Mount Colah Railway Station Footbridge Renewal Project Concept Design (Pre-Construction) Road Safety Audit

Concept Design (Pre-Construction) Road Safety Audit

TTPP Reference: 22248

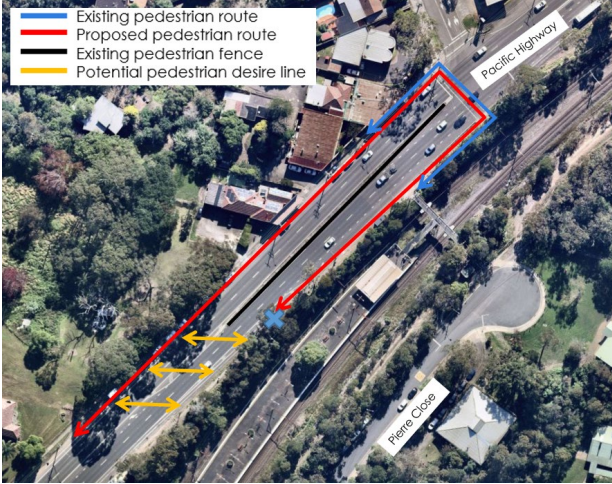
Item No.	Location	Descriptions of Findings	Design/ Photo	Likelihood	Severity	Risk Rating	Designer Comment
1.	Pacific Highway	<p>Relocation of the footbridge may alter the pedestrian desire line across Pacific Highway.</p> <p>The south-western end of the existing pedestrian fencing on the median of Pacific Highway is near the proposed station access and may not deter pedestrians from jaywalking across Pacific Highway. Pedestrians may stage the crossing on the nearby painted median.</p> <p>This deficiency would increase the likelihood of collisions involving pedestrians.</p>	 	Occasional	Moderate	Medium	<p>As per the Reference Design, in CDR set we will show RMS fence on the east side to deter jaywalking to the extent as discussed in meeting held with designers 26/08/2022.</p>

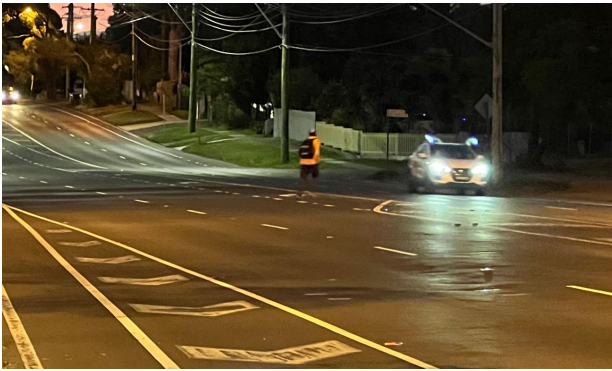
Item No.	Location	Descriptions of Findings	Design/ Photo	Likelihood	Severity	Risk Rating	Designer Comment
2.	Pierre Close	<p>There is no street lighting directly above the proposed pedestrian crossing.</p> <p>Motorists may not see a pedestrian about to step off the kerb or already on the pedestrian crossing during the night time when the visibility is low. This may increase the likelihood of collisions involving pedestrians.</p>		Improbable	Moderate	Low	Street lighting be provided by ASP L3.

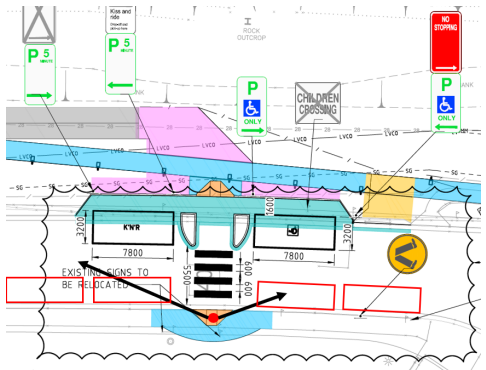
3.	Pierre Close – south side	<p>The design does not show any changes to the existing 15-minute parking restriction on the south-east side of Pierre Close in the vicinity of the proposed pedestrian crossing.</p> <p>There is no provision of a No Stopping zone to prohibit parking on the south-east side of Pierre Close on both sides of the pedestrian crossing, in accordance with TfNSW Technical Direction TDT 2002/12c.</p> <p>Impeded crossing sight distance from the footpath on the south-east side of Pierre Close by parked vehicles adjacent to the crossing would increase the likelihood of a crash involving a pedestrian.</p>	 	Occasional	Moderate	Medium	<p>New traffic signs and/or marking to be provided to compliment the new layout.</p> <p>Civil – Traffic drawings should be added to the CDR set.</p>

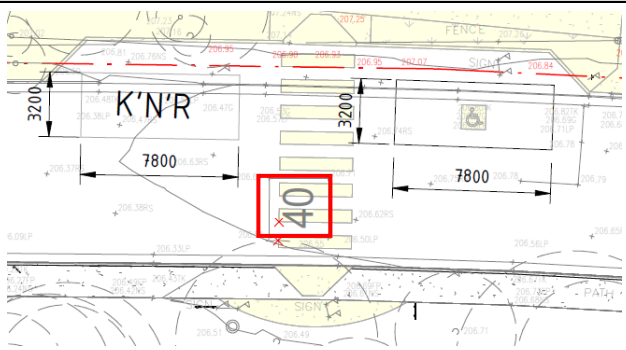
Item No.	Location	Descriptions of Findings	Design/ Photo	Likelihood	Severity	Risk Rating	Designer Comment
4.	Pierre Close	<p>The design does not indicate any changes to the 40km/h School Zone pavement marking where the proposed pedestrian crossing will be located.</p> <p>As such, the 40km/h School Zone pavement marking will be covered by the proposed pedestrian crossing pavement marking.</p> <p>Consequently, motorists may not be aware of the speed limit and travel above the speed limit. This may result in possible conflicts with other road users.</p>	 	Improbable	Moderate	Low	<p>New traffic signs and/or marking to be provided to compliment the new layout.</p> <p>Civil – Traffic drawings should be added to the CDR set.</p>

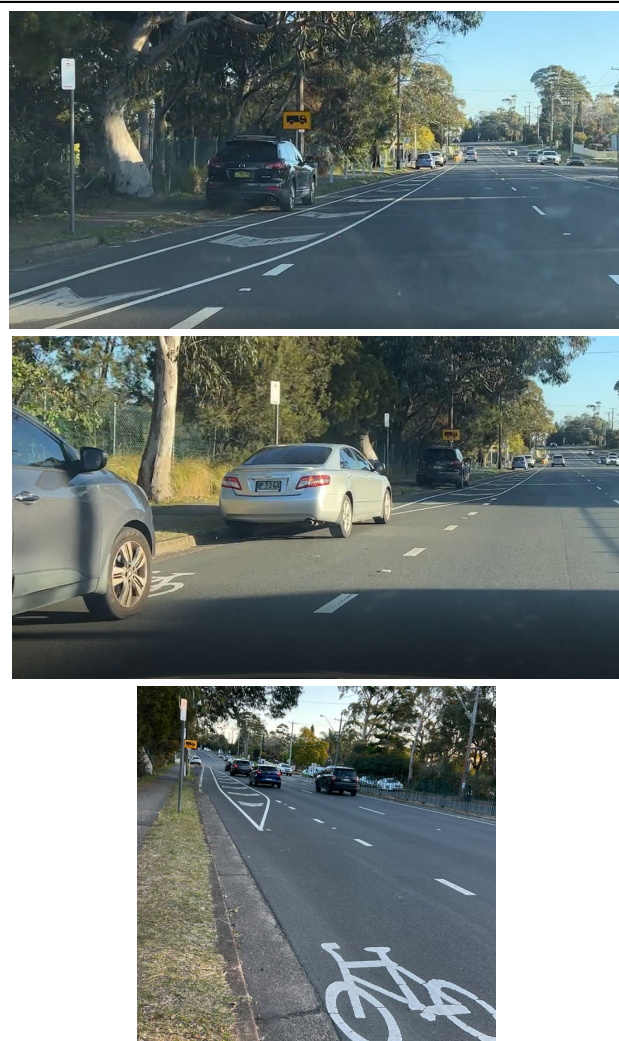
9.	Pierre Close	<p>The Children Crossing signage is to be removed. The proposed concept design does not mention removal of Children Crossing line marking.</p>	<p>The photograph shows a road with a 'CHILDREN CROSSING' sign on the left and a white line marking on the road. The design drawing below shows a 'CHILDREN CROSSING' sign with a large 'X' over it, indicating it should be removed. It also shows 'LVCO' and 'SG' markings on the road.</p>		Note only		<p>These items will be included in Architectural Demolition Plan.</p>
